Declaration of changes between V1140-103 (certification parent variant) and the V1140-105 (NA child variant)

Appendix:
Unnecessary components removed from WCDMA Band1 and Band8 diversity RX path

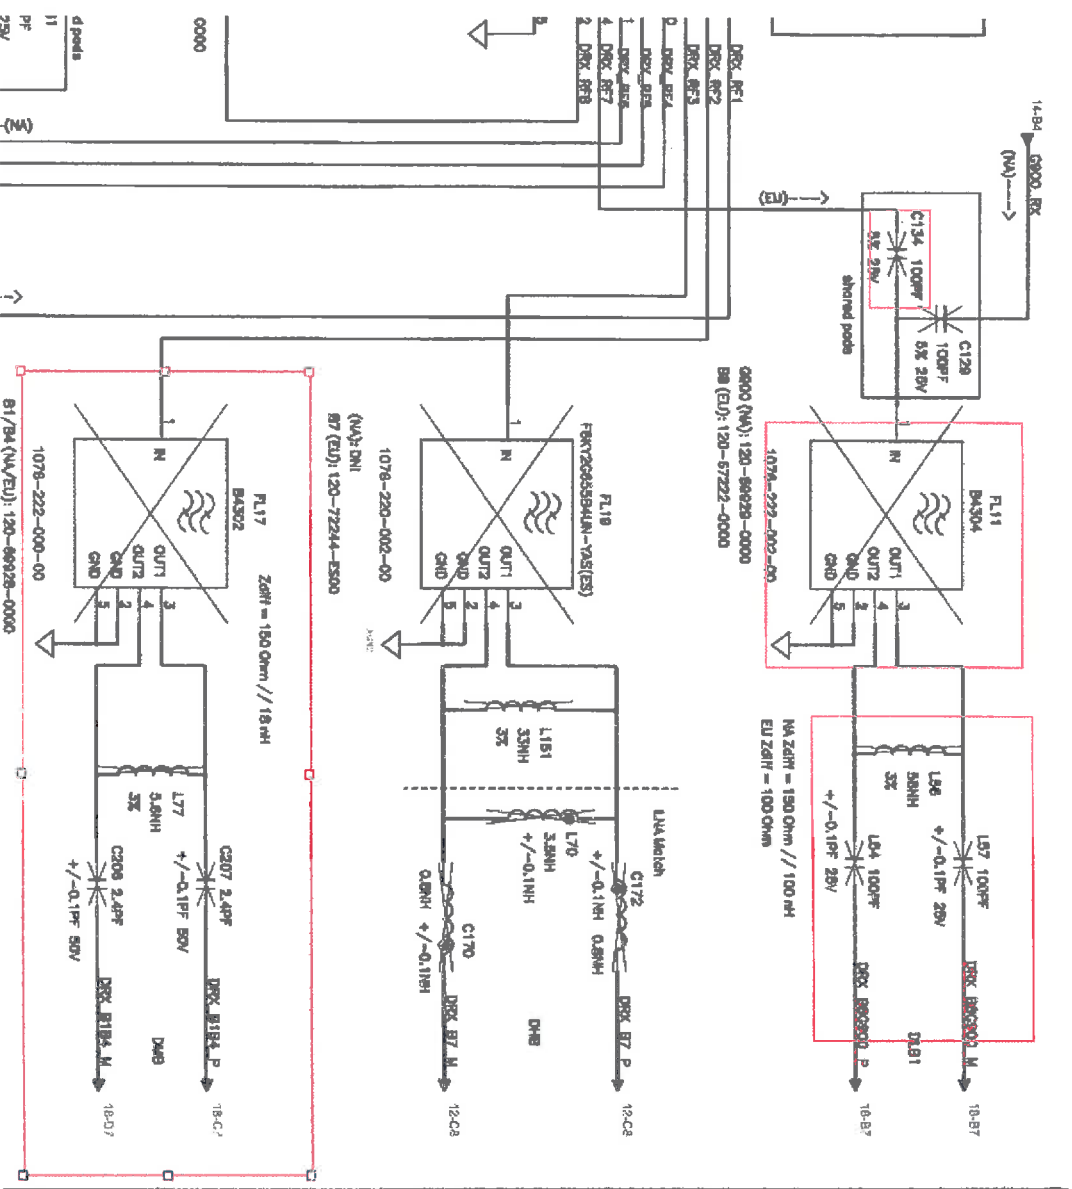
Unnecessary components in the WCDMA band 1 TX path and primary RX path and secondary (diversity) RX path are removed

Unnecessary components in the WCDMA band 8 TX path and secondary (diversity) RX path are removed, the primary RX path is untouched, the Band 8 duplexer is still populated, but now terminated with 50 Ohms at its TX input where in V1140-103 the B8 power amplifier was connected. The B8 duplexer is still populated because its RX path is still needed for GSM900 receive.

Necessary components removed from WCDMA Band1 TX and primary RX path
 L12, C50 removed in Band 8 TX path, duplexer terminated by 50 Ohms populated on placeholder L14.
